**From:** Paul Maxwell  
**Sent:** Monday, 11 December 2017 10:23 AM  
**To:** 'Doug and Helen'  
**Subject:** Clarification of Activities for Walls Bay Application :Doug's Opuā Boat Yard

**From:** Doug and Helen <totarahill@xtra.co.nz>  
**Sent:** Tuesday, 12 December 2017 8:01 AM  
**To:** Paul Maxwell  
**Subject:** APP.039650.01.01

REF: EROSION CONTROL SEAWALL CROSS-SECTION

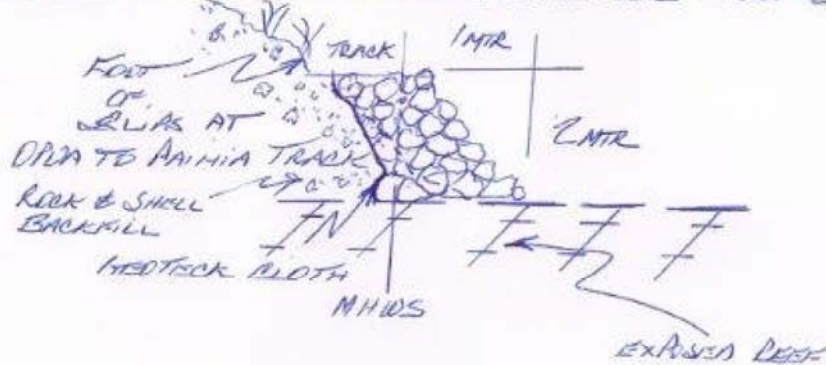
The application plans show that additional erosion control (seawall) structures are proposed to be placed along the MMHWS boundary north of the existing jetty. Can you please provide a dimensioned typical cross section showing the proposed construction/design of the seawall, its proposed maximum length and indicating where it will start and terminate along the shoreline.

As to the Erosion Control Seawall, in particular to the stones used and back fill; sizes may vary and back fill can be small stones and broken shell from the beach rehabilitation. The end effect is a uniform walking track leading north to the point with no open slip face in the tidal zone at the northern side of the bay.

REF: BEACH REHABILITATION GIGLY SCREEN

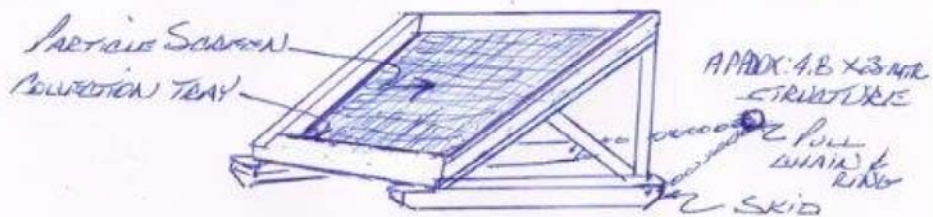
The application discusses activities to rehabilitate the beach. From our discussion this appears to be sifting of beach sands to remove sharp shell and other coarse debris to improve the amenity of the beach. Please describe how you proposed to undertake this beach rehabilitation, including the use of any machinery on the foreshore and provide a marked up diagram/aerial photograph showing the extent of the proposed beach rehabilitation area.

TO MOVE ALONG AN 8 MTR BAND OF BEACH FROM MHW'S SEAWARD REMOVING BROWN & BLUE ROCK, SHELL, AND OYSTER CLUMPS LONG DEAD. LEAVING SAND & FINE PEBBLES UP TO A CENTIMETER IN DIAMETER. REMOVE DEBRIS TO BACK FILL EROSION CONTROL SEAWALL. SEE
